Access Compliance Report

Public Rights-of-Way

(Curb Ramps)

Intersection ID: 44417	Main Street: MARVIN_RD	Cross Street: ARDREY_KELL_RD	Location: NE
ADA ID: 1E4841162DAE	Ramp Type: Perp	Initial Pass/Fail: Fail	Overall Compliance: No
Severity Score: 21.25			
Codes/Mitigation Info/Possible Solution		Field Measurements/Component Compliance

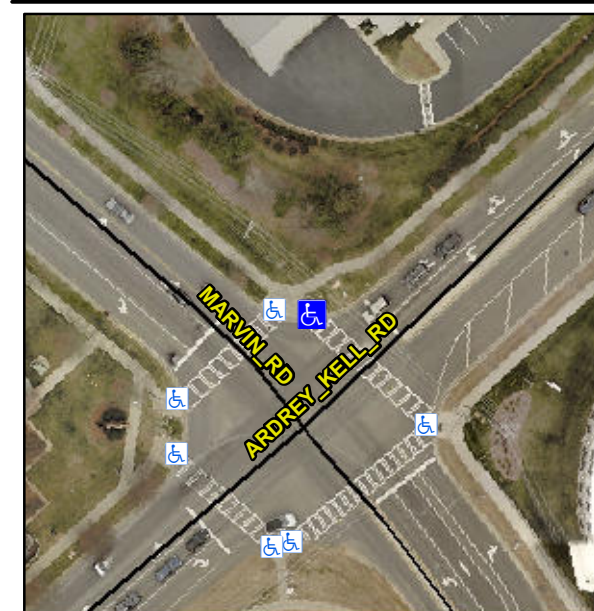
Not Found, R304.5.1, R304.5.3

Compliance	Description	Data	Compliance	Description	Data
N/A	Ramp Length (in)	91.0	Yes	Ramp Slope (%)	7.1
No	Ramp Width (in)	47.0	No	Ramp XSlope (%)	5.5
N/A	Flare Type LT	N/A	N/A	Flare Type RT	N/A
N/A	Flare Slope LT (%)	N/A	N/A	Flare Slope RT (%)	N/A
N/A	Flare Traversable LT?	N/A	N/A	Flare Traversable RT?	N/A
N/A	Landing Length (in)	N/A	N/A	DWS Provided?	N/A
N/A	Landing Width (in)	N/A	N/A	DWS Contrast?	N/A
N/A	Landing Slope (%)	N/A	N/A	DWS Length (in)	N/A
N/A	Landing X Slope (%)	N/A	N/A	DWS Full Width?	N/A
N/A	Landing Curb? (Y/N)	N/A	N/A	DWS Offset (in)	N/A
N/A	Shared Landing?	N/A			
N/A	Gutter Ponding?	N/A	N/A	Gutter Slope (%)	N/A
N/A	Gutter Lip Ht (in)	N/A	N/A	Gutter X Slope (%)	N/A
N/A	Painted X Walk1?	Yes	N/A	Painted X Walk2?	N/A
	X Walk 1 Direction	To SE		X Walk 2 Direction	N/A
N/A	X Walk 1 Width (in)	111.5	N/A	X Walk 2 Width (in)	N/A
	X Walk 1 Slope (%)	0.8		X Walk 2 Slope (%)	N/A
	X Walk 1 X Slope (%)	2.8		X Walk 2 X Slope (%)	N/A

Remove & Replace Entire Ramp.
